# UPGRADES AND RENOVATIONS MISSOURI VETERANS HOME

2400 Veterans Memorial Dr.  
Cape Girardeau, MO 63701

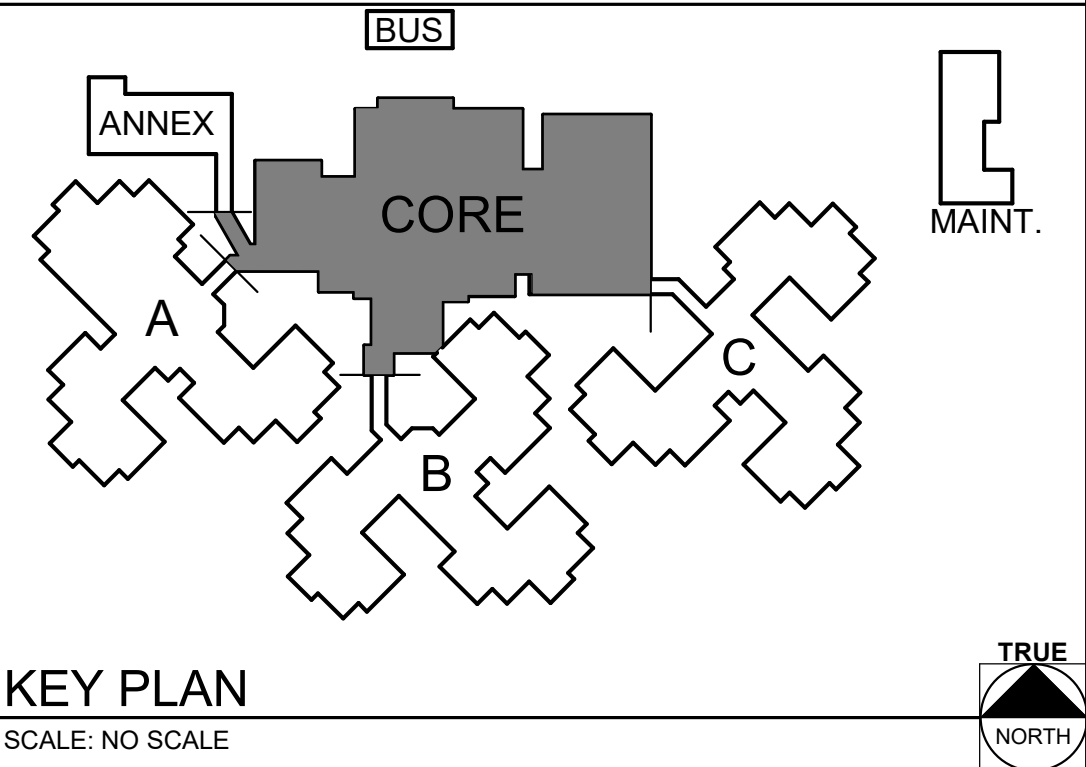
- 1 PC TO DEMARCAT FLOOR AREA FOR REMOVAL BY GC TO ACCOMMODATE NEW UNDERFLOOR PLUMBING. PC TO PROVIDE EXCAVATION FOR ASSOCIATED WORK.
- 2 PC TO THOROUGHLY REVIEW EXISTING CONDITIONS AND INCORPORATE INTO BID ALL WORK ASSOCIATED WITH SYSTEM DRAIN DOWN AND MODIFICATIONS NEEDED TO CONNECT TO EXISTING DOMESTIC WATER PIPING WHERE INDICATED. SEE NEW WORK PLANS FOR CLARIFICATION.

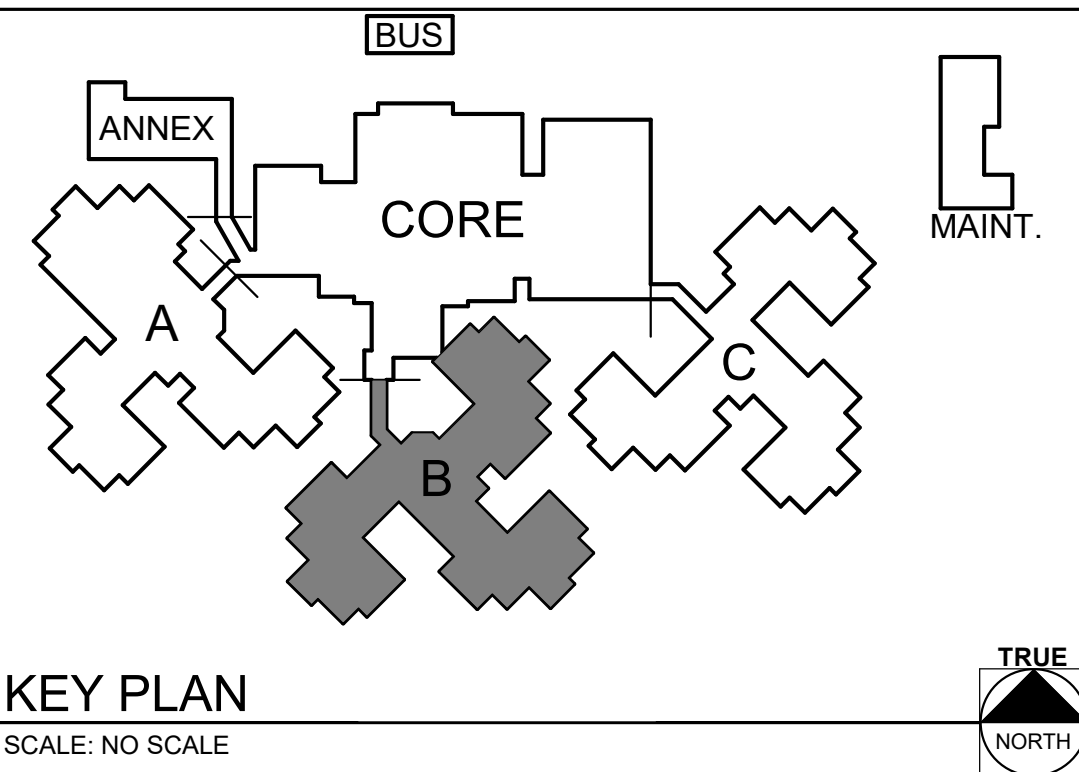
- 1 PC TO DEMARCAT FLOOR AREA FOR REMOVAL BY GC TO ACCOMMODATE NEW UNDERFLOOR PLUMBING. PC TO PROVIDE EXCAVATION FOR ASSOCIATED WORK.
- 2 NO PLUMBING WORK THIS AREA.
- 3 PC TO DRAIN DOWN DOMESTIC WATER SYSTEM TO ALLOW FOR NEW CONNECTIONS THIS AREA. SEE NEW WORK PLANS FOR CLARIFICATION.
